RESPONSE TO REQUEST FOR ADDITIONAL INFORMATION

APR1400 Design Certification

Docket No. 52-046

RAI No.: 387-8485
SRP Section: 15.00.02 – Review of Transient and Accident Analysis Methods
Application Section: 15.00.02
Date of RAI Issue: 02/01/2016

Figure 1. A Typical Interpolation Scheme

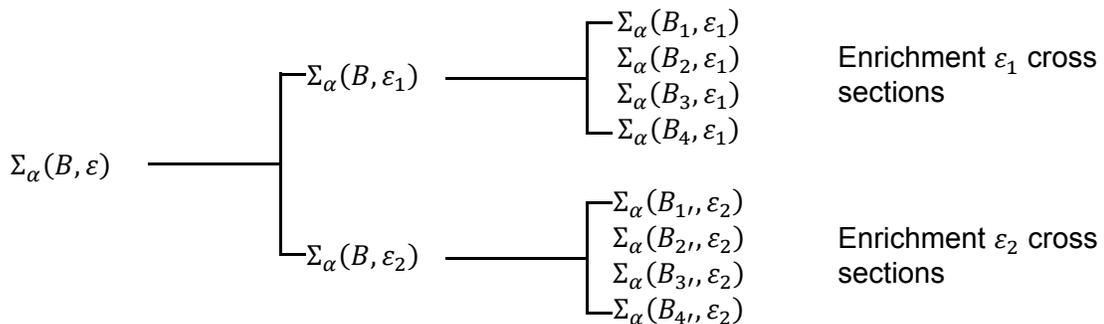
In DCD Section 4.3.3.1.1.3, the following statement is made: "The ROCS embedded calculation uses a macroscopic cross-section model based on interpolation of multi-dimensional macroscopic tables. These tables are created by the MCXSEC code, which processes DIT results for all assembly types, and are typically burnup, enrichment, moderator, and fuel temperature dependent for each fine-mesh pin cell type." However, the applicant has not provided adequate details on the MCXSEC code and its use with the DIT and ROCS codes to allow the staff to complete its review of this portion of the evaluation model.

Please provide details on the MCXSEC code as it used to generate macroscopic cross sections for ROCS based on results from DIT. As appropriate, the applicant should ensure that the requested information is either added to the DCD itself or else provided in supporting documents that are docketed and listed for incorporation by reference.

As an example, a table that is both burnup and enrichment dependent would follow the scheme diagrammed in Figure 1 below. Interpolation proceeds from right to left in the figure.

Mathematically the figure implies the following interpolation formula:

$$\Sigma_{\alpha}(B, \varepsilon) = \left(\frac{\varepsilon_2 - \varepsilon}{\varepsilon_2 - \varepsilon_1} \right) \left[\left(\frac{B_3 - B}{B_3 - B_2} \right) \Sigma_{\alpha}(B_2, \varepsilon_1) + \left(\frac{B_2 - B}{B_2 - B_3} \right) \Sigma_{\alpha}(B_3, \varepsilon_1) \right] + \left(\frac{\varepsilon_1 - \varepsilon}{\varepsilon_1 - \varepsilon_2} \right) \left[\left(\frac{B_{2'} - B}{B_{2'} - B_{1'}} \right) \Sigma_{\alpha}(B_{1'}, \varepsilon_2) + \left(\frac{B_{1'} - B}{B_{1'} - B_{2'}} \right) \Sigma_{\alpha}(B_{2'}, \varepsilon_2) \right]$$
